# CITY OF CONWAY, ARKANSAS HISTORIC DISTRICT COMMISSION

February 26, 2024 • 5:30pm • 1111 Main Street

# 1506 Prince Street-Residential Remodel

# 1904 Robinson Ave-Porch Addition

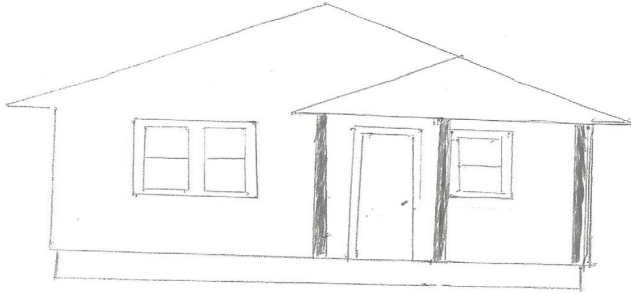
*The new window is on the west side elevation. The door being filled in does not appear to be original. It faces east and has a different trim than the front door.*

### GROTH FRONT EXTERIOR ELEVATIONS

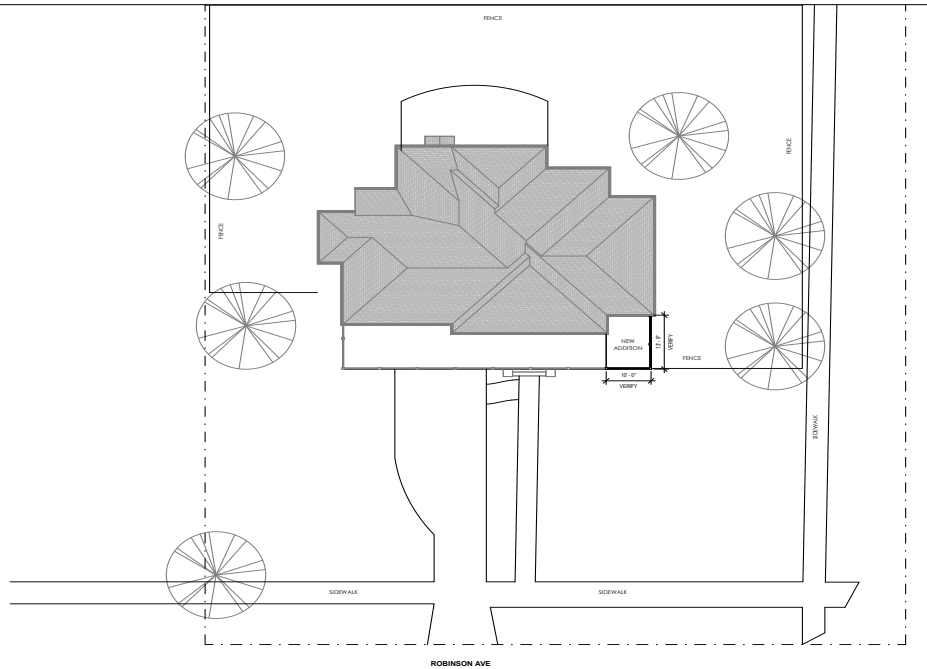
*Decorative stucco and ½ timber with circular pattern will be obscured in part by porch addition. All other character-defining features on the building will be retained.*

*A trellis will be removed. The front porch roof will be extended to cover the side porch. The windows on the residence, currently obscured by the trellis, will now be visible from the public realm.*

*The porch is existing on the front elevation and already includes a brick railing which extends along the front façade of the residence. Because the materials will match existing, the extension of the porch roof will not overpower or change the mass of the building.*

*Proposal includes wood railing to match existing, wood beam to match existing, and brick wrapped column with concrete cap to match existing.*

*No windows or doors are proposed. Two windows and one door will now be more visible. They appear historic in design and complement the structure and appear to conform with district guidelines.*

- 1.Applicant must obtain all applicable building permits\* if/when a Certificate of Appropriateness is granted
- \*Applicant shall provide proof of appropriate licensure of professionals performing work to the Building Permits Department
- 2.Materials shall match those proposed and approved through this review as shown on the attached site plan and elevations.
- 3.Any window replacement or installation requires review by the HDC.
- 4.If the existing sidewalk is damaged during construction, it must be repaired.
- 5.Lighting shall be inward, downward, and shrouded to stay within the bounds of the property.

1828 MILL STREET  
EXTERIOR ELEVATIONS

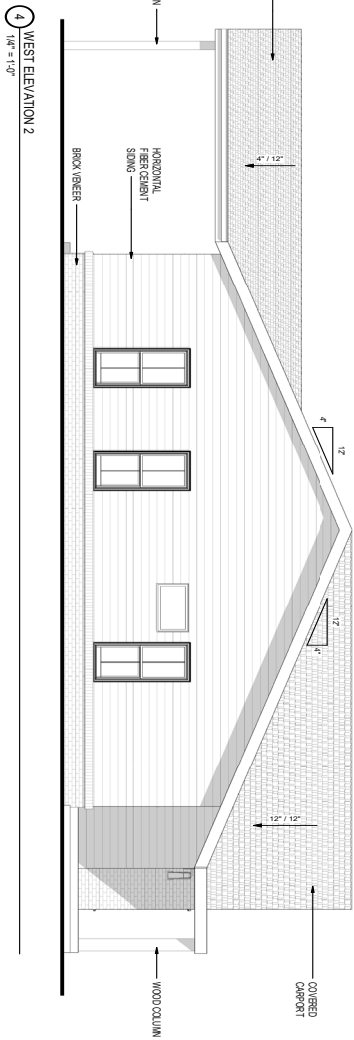
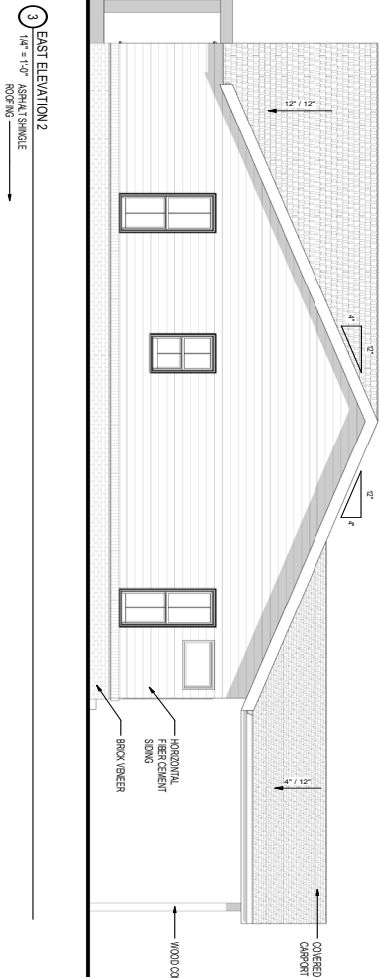
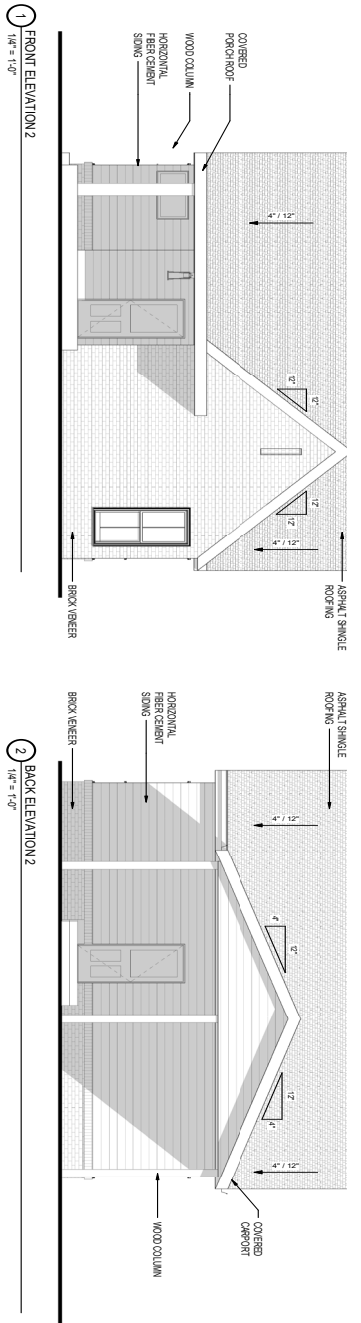
*All elevations contain windows including several on the front facade, however, the front elevation needs an additional window. The rear elevation would benefit from the inclusion of at least one window.*

*A front porch with a 12' depth is proposed and meets the requirements. The proposed windows should feature wide trim and one-over-one design is encouraged. Fake muntin bars are prohibited.*

*The applicant is proposing fiber cement siding with a front façade composed partly of brick veneer as well as a brick veneer skirt.*

*No shutters are being proposed which is desirable. The applicant is proposing a gable roof with asphalt shingles. This is compatible with surrounding homes.*

2. Prior to issuance of a Certificate of Appropriateness, applicant shall submit to the Planning Department for review and approval, elevations showing one additional window on the front elevation for a total of three windows.

4. Windows shall be at least one-over-one (not fixed windows). If muntin bars are used, they must be true divided lights.
5. Driveway shall be concrete, pavers, or permeable paving between with the apron on Mill St being between 8' and 12' wide.

# 1828 MILL STREET ARCHITECTURAL SITE PLAN

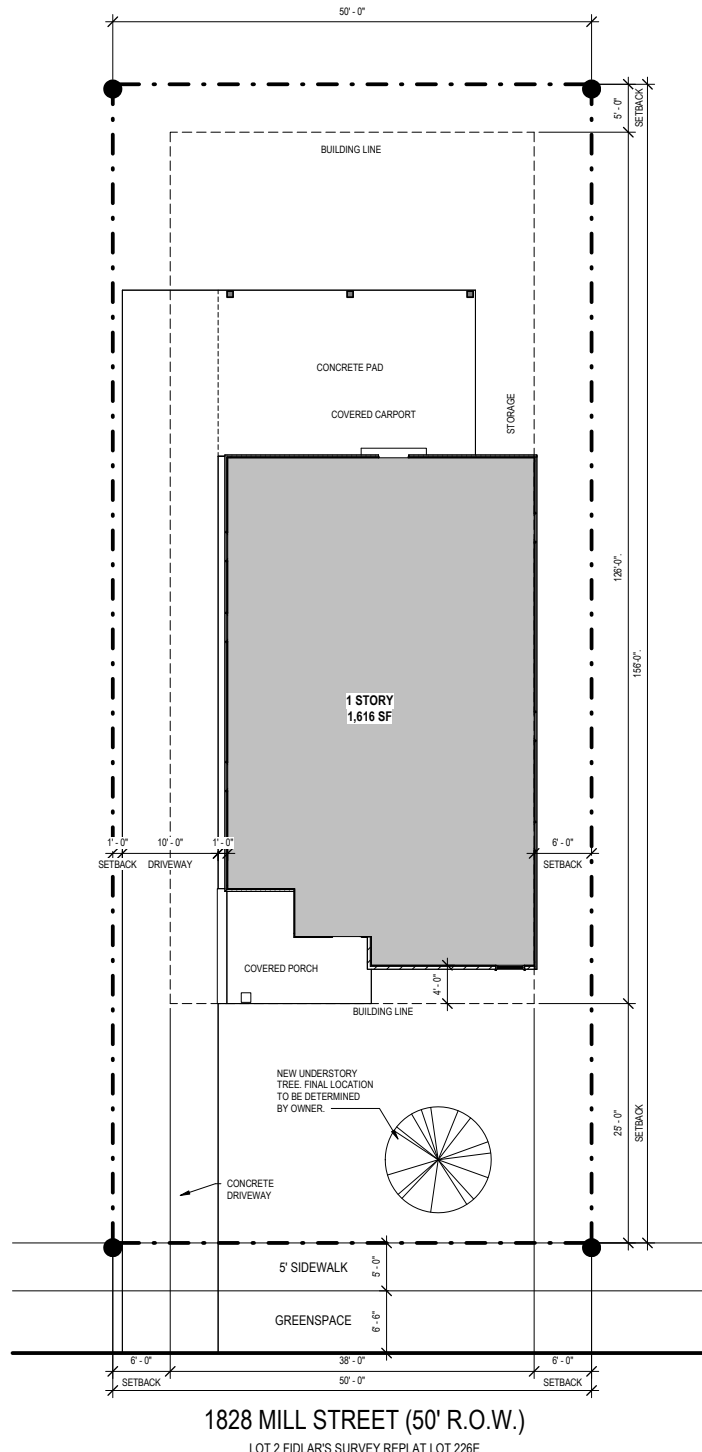
*The applicant is proposing a front setback of 25'; Side yard setbacks of 6' and 10'; Rear setbacks of approximately 25'. The proposed setbacks meet the requirement.*

*The applicant has indicated a driveway off Mill St near the western property line. It is 10ft wide and terminates at the carport and concrete pad located at the rear of the residence.*

*There is an existing sidewalk in disrepair. The applicant will need to restore it as a condition of approval. The restored sidewalk can maintain the existing width, both of the sidewalk and the greenspace.*

3. One tree from the OCDOD approved tree list shall be planted. If beneath the power line it shall be an understory tree and if away from the power line it shall be a canopy tree

6. The existing sidewalk and driveway apron will need to be repaired. The width of the sidewalk and greenspace may remain the same to be in harmony with existing sidewalk network.

PROPOSED ELEVATIONS  
BMB CREATIONS REMODEL

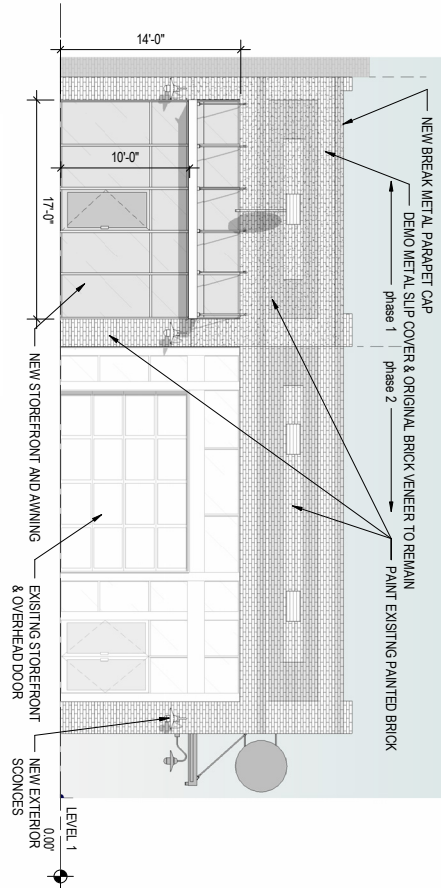
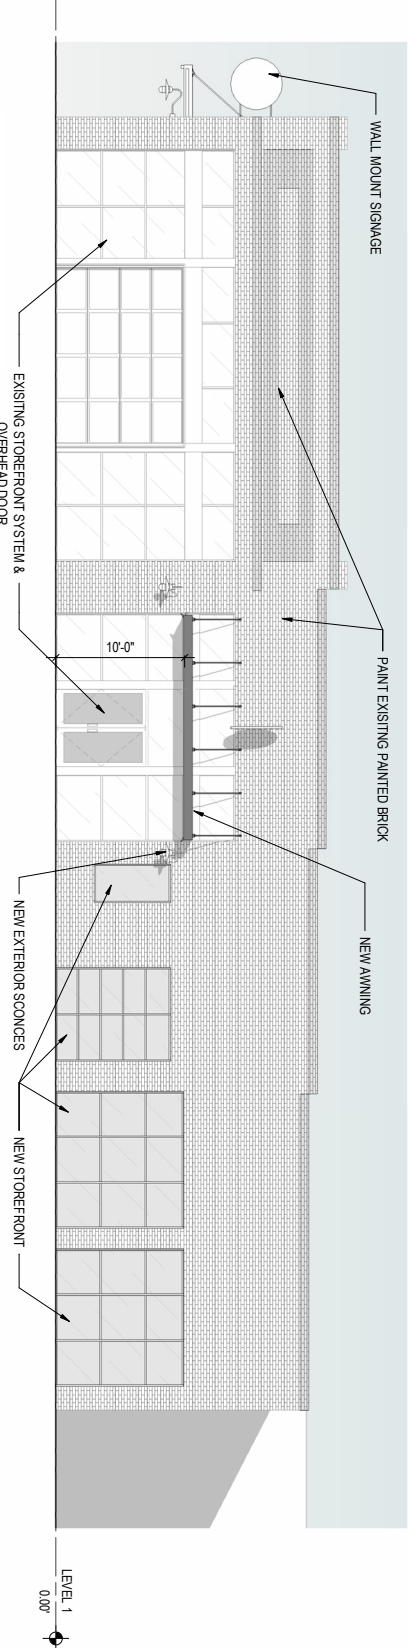
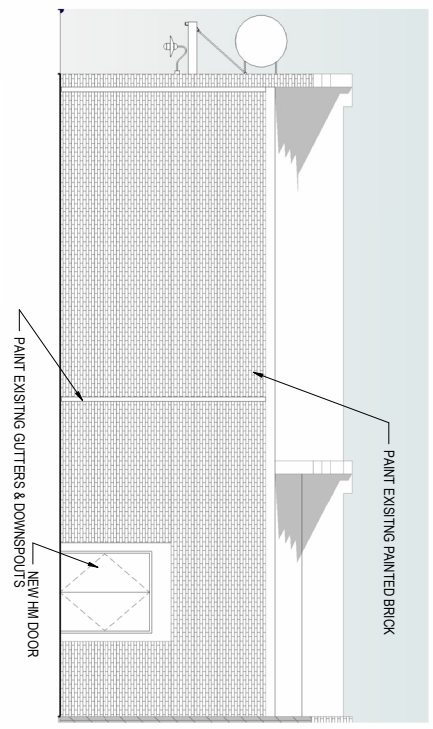
*The facades include an appropriate amount of articulation. There are no large, unarticulated walls. Two-thirds (2/3) of the first story are windows. The first story windows are not 3' above ground level. 802 Front St has been open air for much of its frontage as recently as 2019 and was closed in with all windows which were not 3' above ground level. 804 Front St includes windows that extend to the ground plane.*

*Applicant is proposing additional windows. Other than awnings and sconces, all other building material is existing, including the painted brick, which will be repainted.*

*Two awnings are proposed.*

*Two projecting signs are proposed which are appropriate.*

3. Eighty-five percent (85%) of all first story glazing shall be transparent.

4. All signage shall comply with Old Conway Overlay District guidelines and regulations detailed in Article XII of the Conway Zoning Code. All signage is permitted separately from all review and building permit processes.
